**2022 Master Plan Proposal to  
City of Puyallup, Washington  
December 15, 2023**

## SUMMARY OF PROPOSAL

FIGURE II-A: REGIONAL VICINITY MAP I

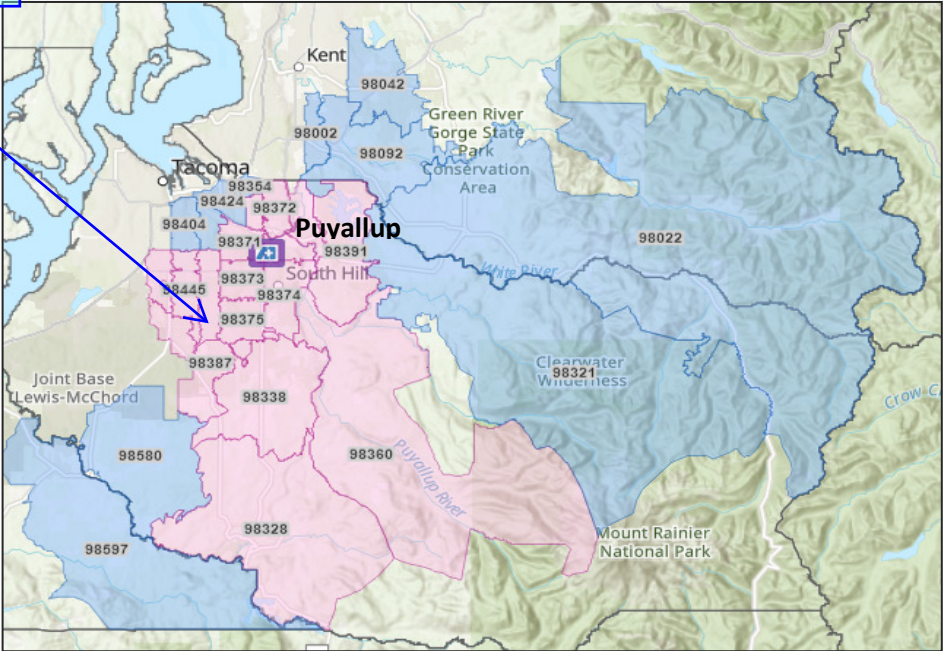
Identify the color coding.  
[Mstr Plan; Pg 10 of 145]

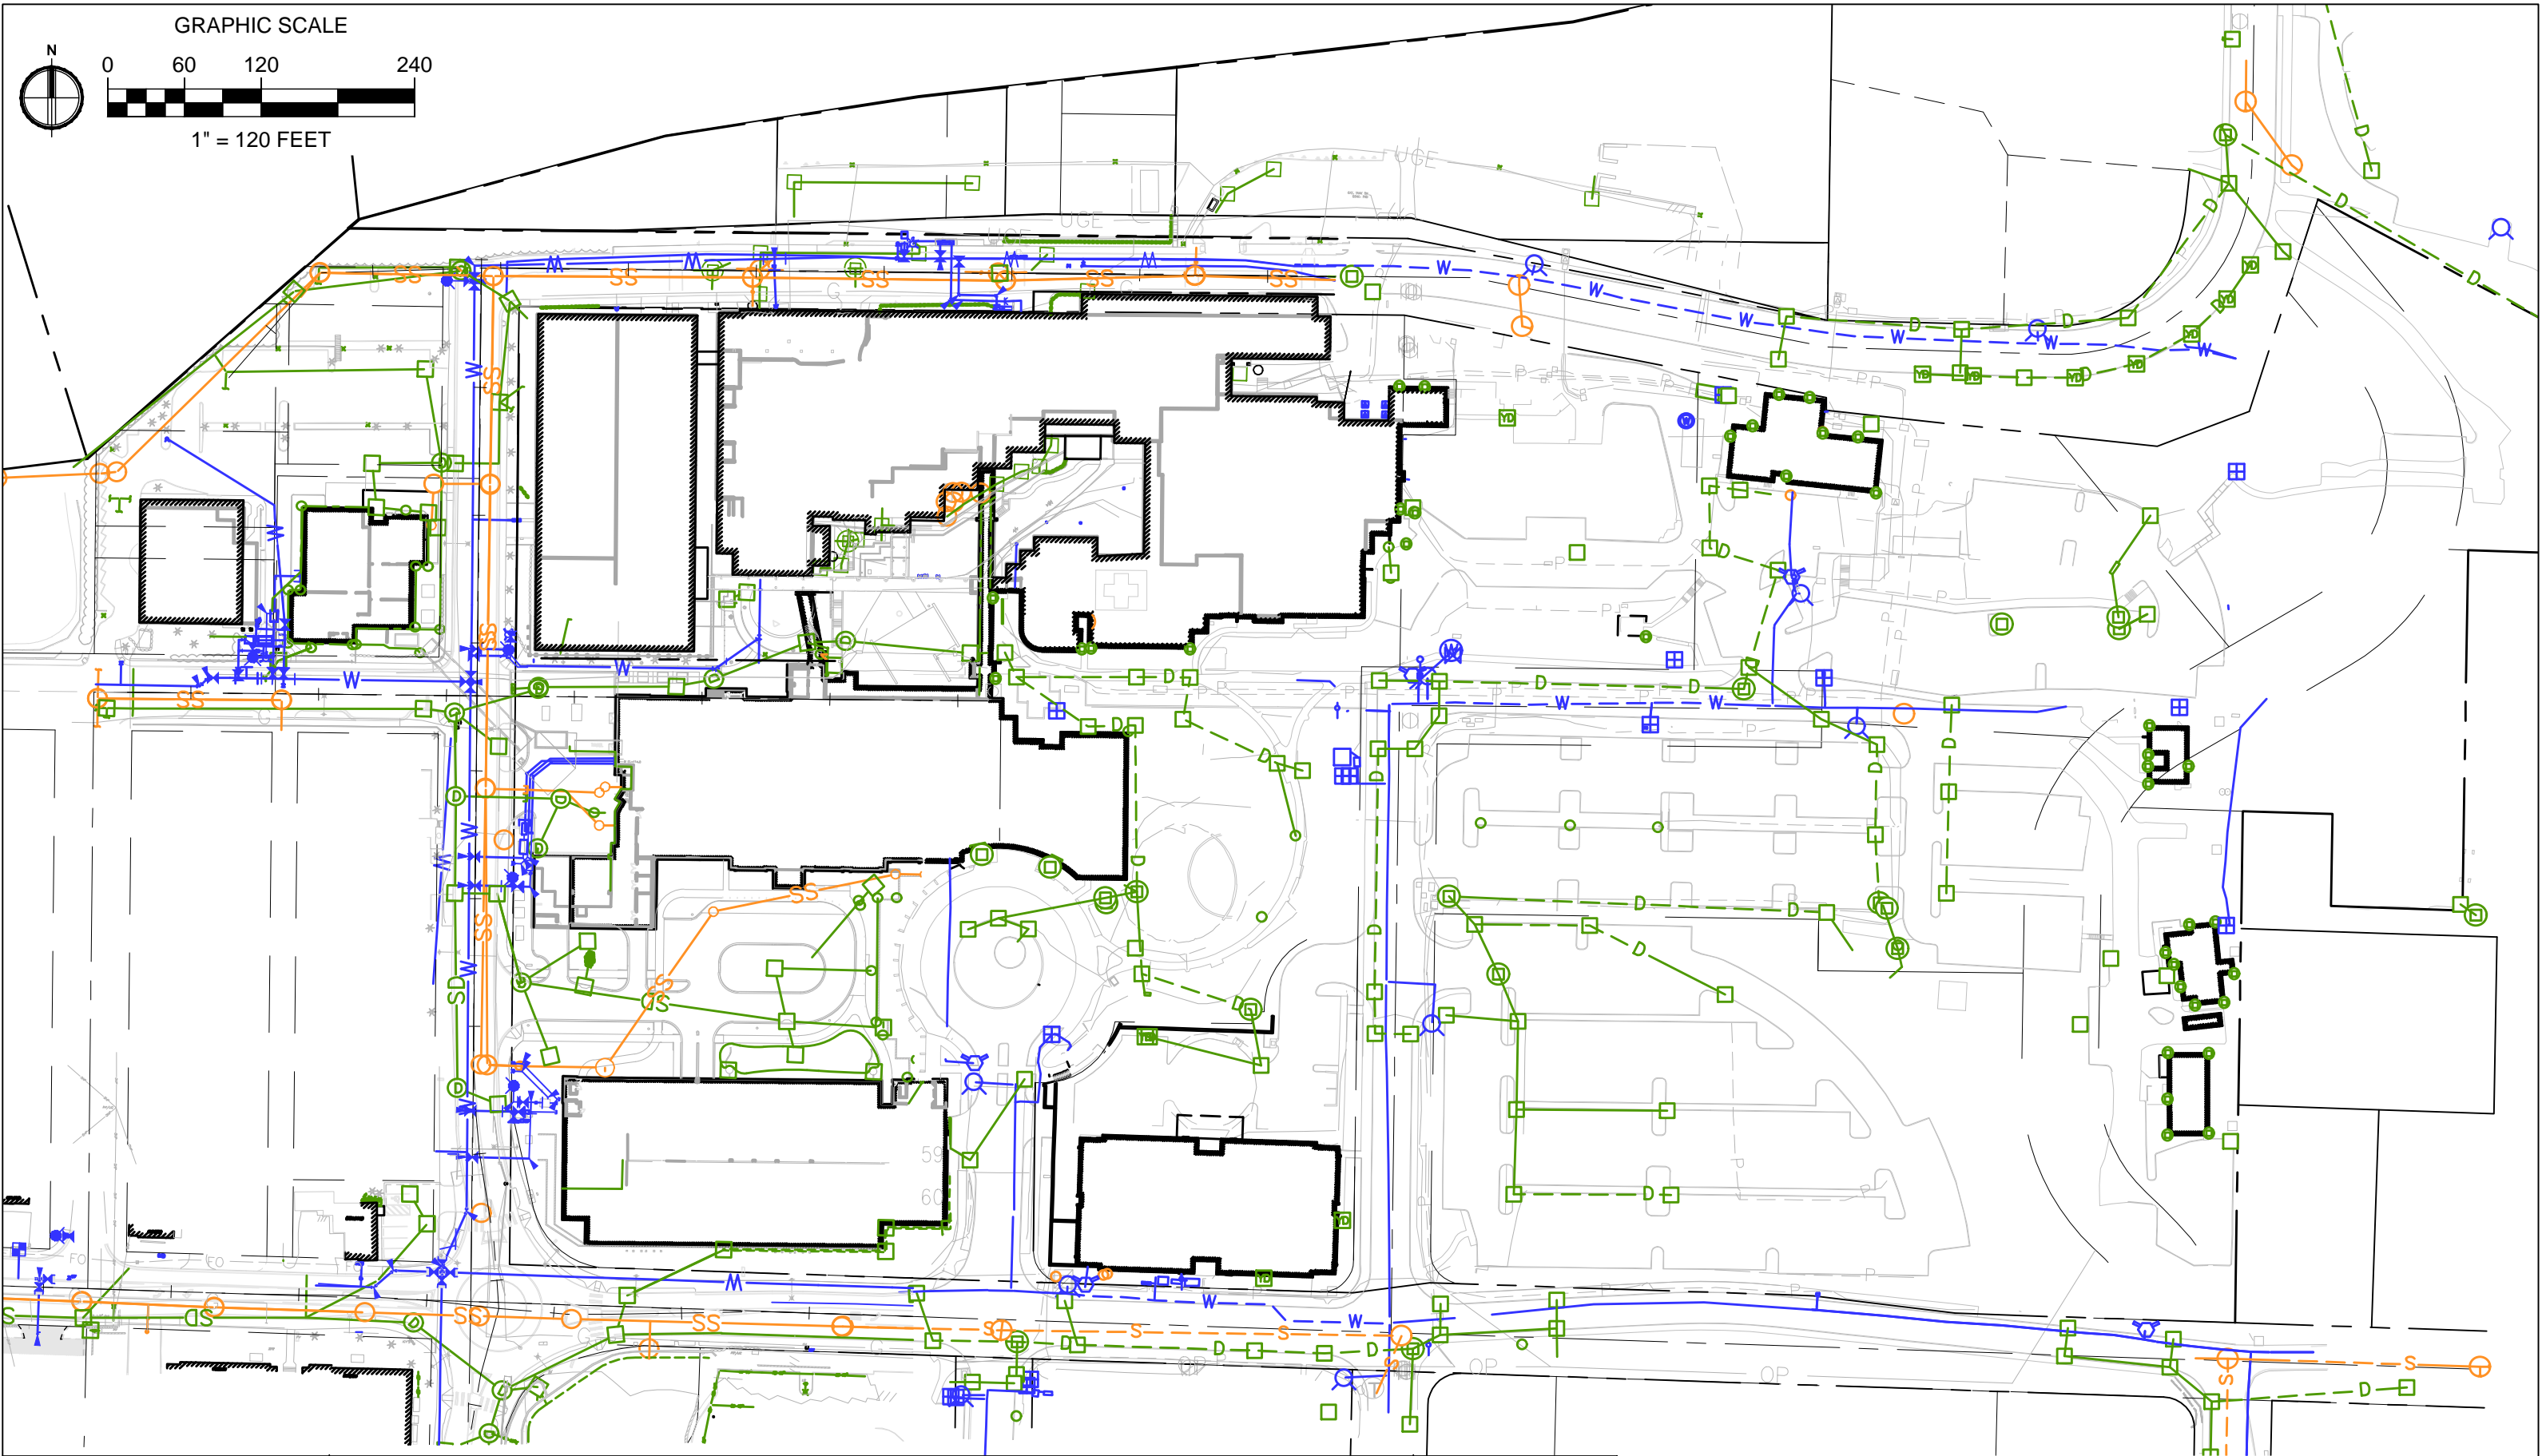
"under SR512 and in line  
with 14th Ave SW"  
[Mstr Plan; Pg 28 of 145]

Additional clarification is needed here...the City's State Highway basin discharges to a conveyance system located within the SR512 right-of-way and is under WSDOT jurisdiction. There are two individual approved drainage manuals that will apply to the MGS project, i.e., the 2019 Ecology Manual (City jurisdiction) and the 2019 Highway Runoff Manual (WSDOT jurisdiction). [Mstr Plan; Pg 29 of 145]

"comply with"  
[Mstr Plan; Pg 29 of 145]

"within each jurisdiction's approved manual as applicable."  
[Mstr Plan; Pg 29 of 145]

"and downstream analyses"  
[Mstr Plan; Pg 29 of 145]

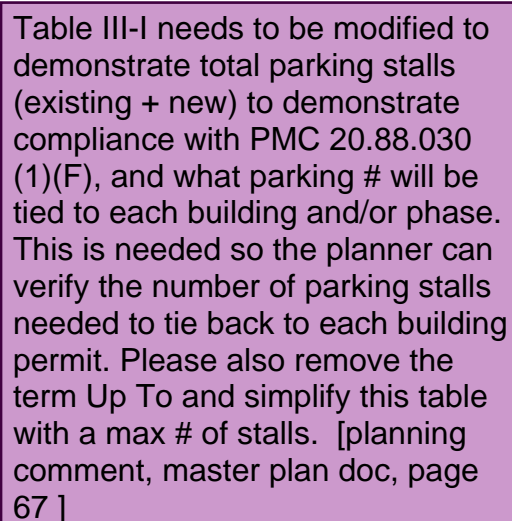
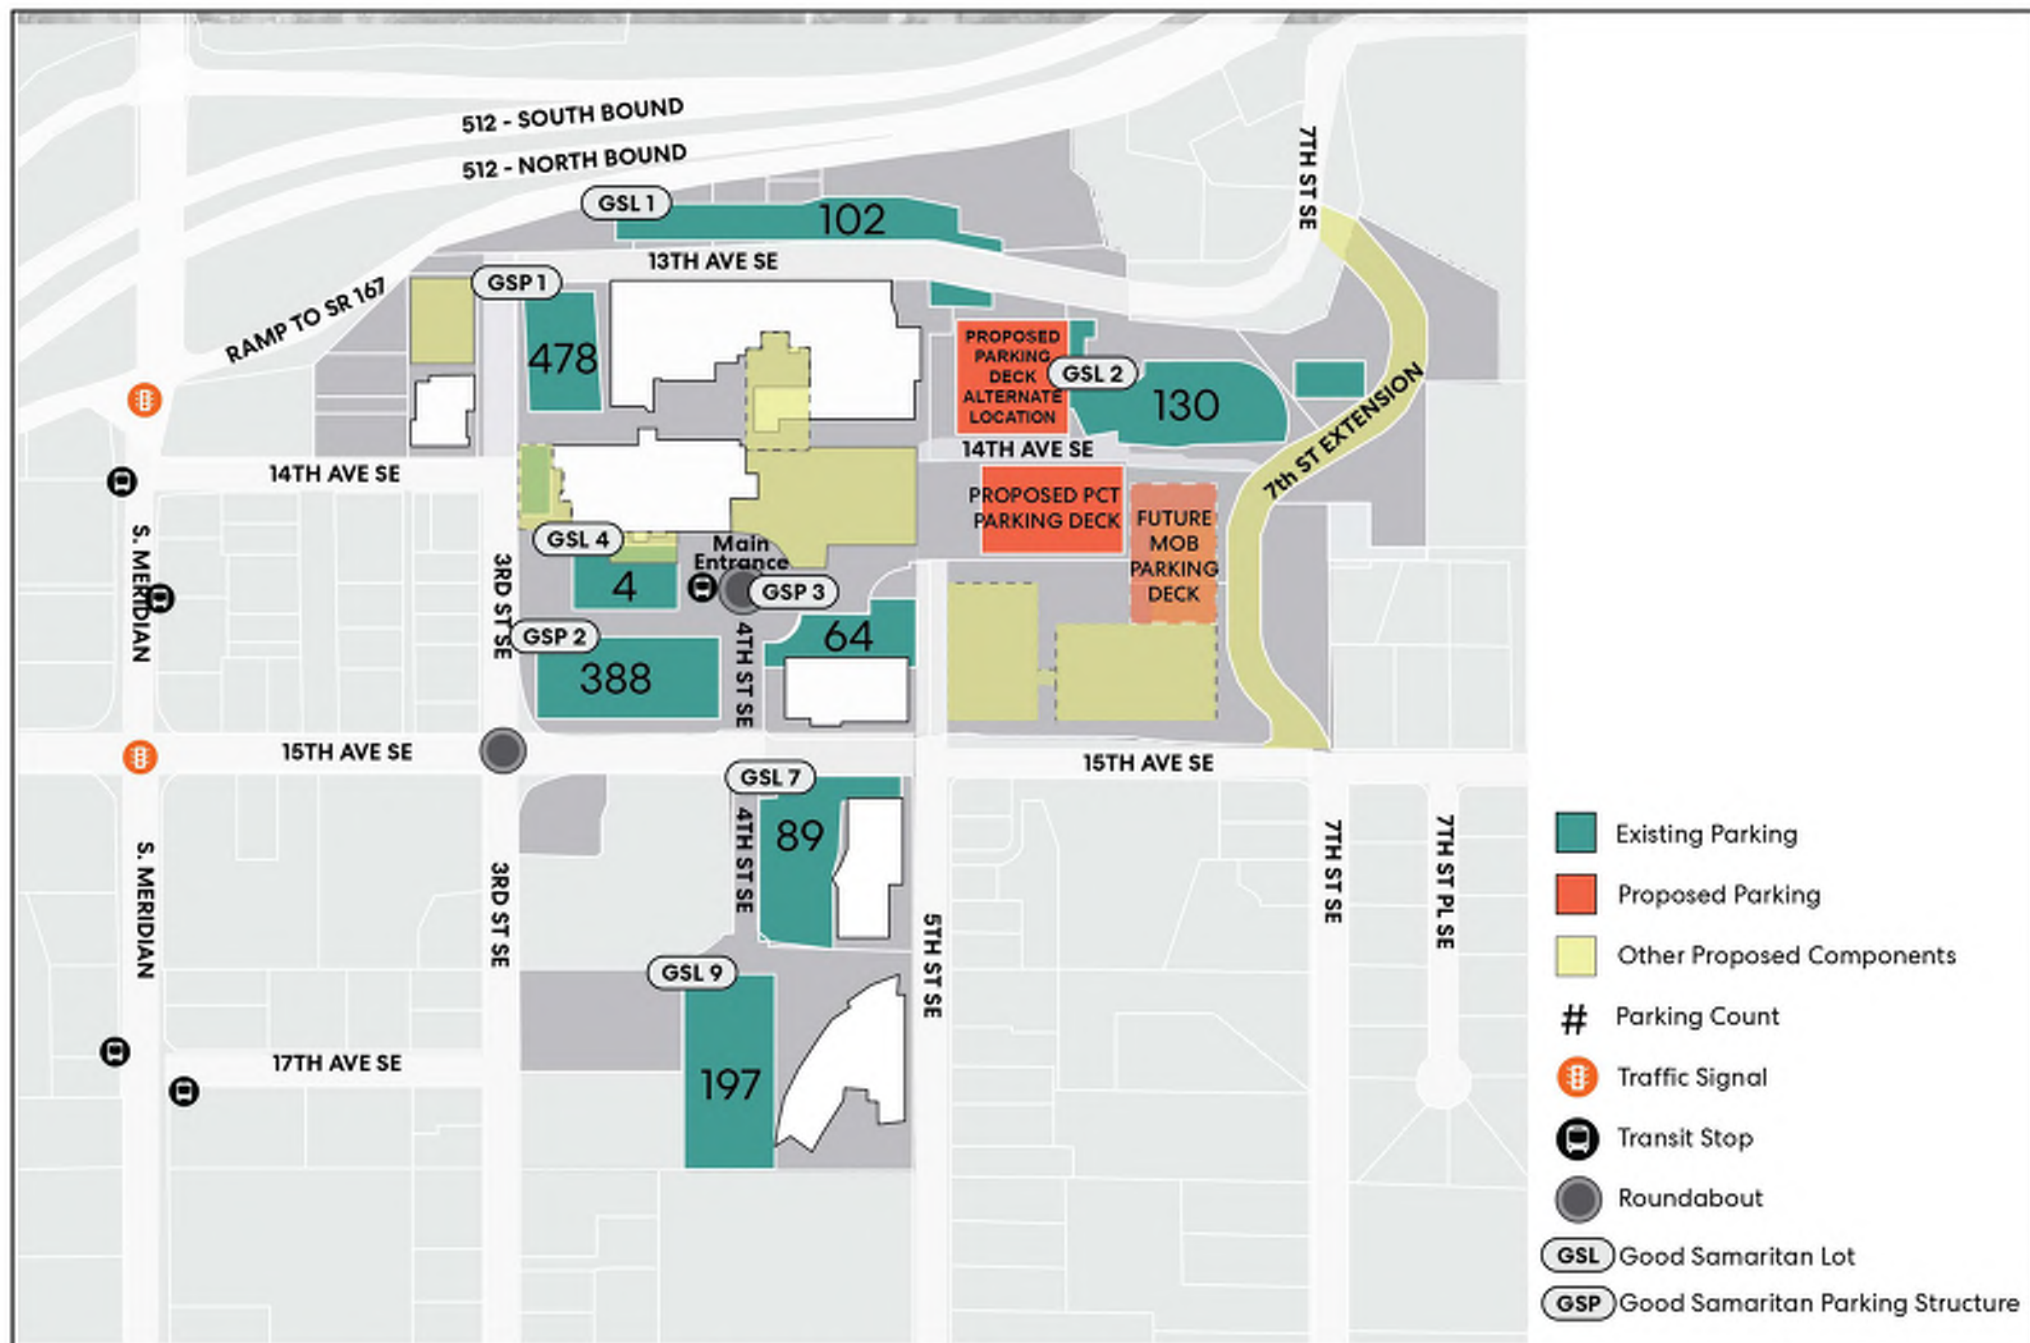
Table III-I needs to be modified to demonstrate total parking stalls (existing + new) to demonstrate compliance with PMC 20.88.030 (1)(F), and what parking # will be tied to each building and/or phase. This is needed so the planner can verify the number of parking stalls needed to tie back to each building permit. Please also remove the term Up To and simplify this table with a max # of stalls. [planning comment, master plan doc, page 67 ]
